PLAN-005886

22/04/2014

Proposal: Ground floor extension for WC.
Site: 10 Warren Way, Barnham, PO22 0JX.
EG/14/14/HH

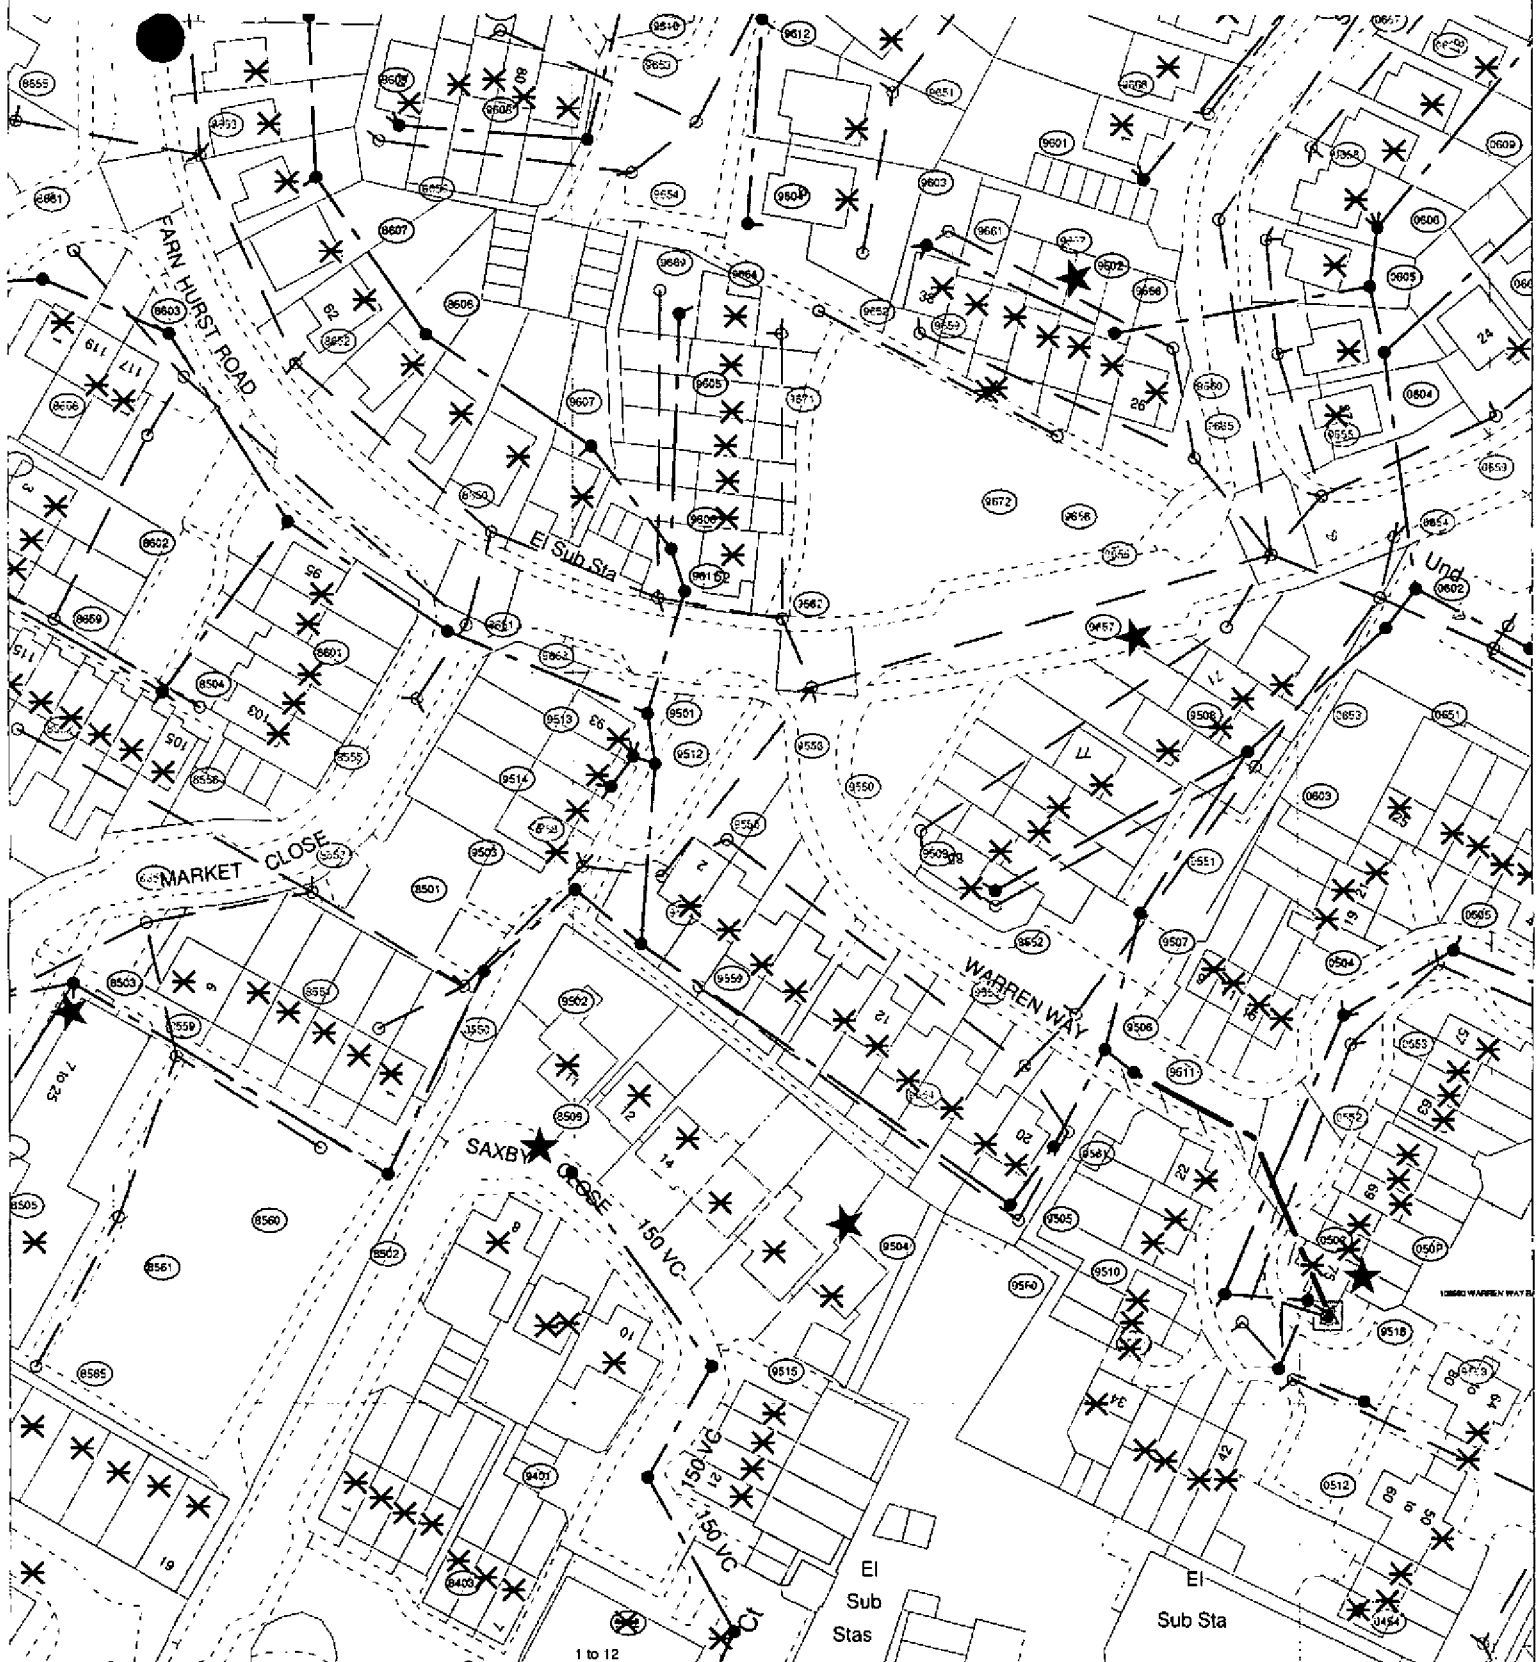
Please find attached a plan of the sewer records showing the approximate position of foul and surface water sewers crossing the site. The exact position of foul and surface water sewers must be determined on site by the applicant before the layout of the proposed development is finalised.

- No development or new tree planting should be located within 3 metres either side of the centreline of the foul and surface water sewers.
- No new soakaways should be located within 5m of public sewers.
- All existing infrastructure should be protected during the course of construction works.
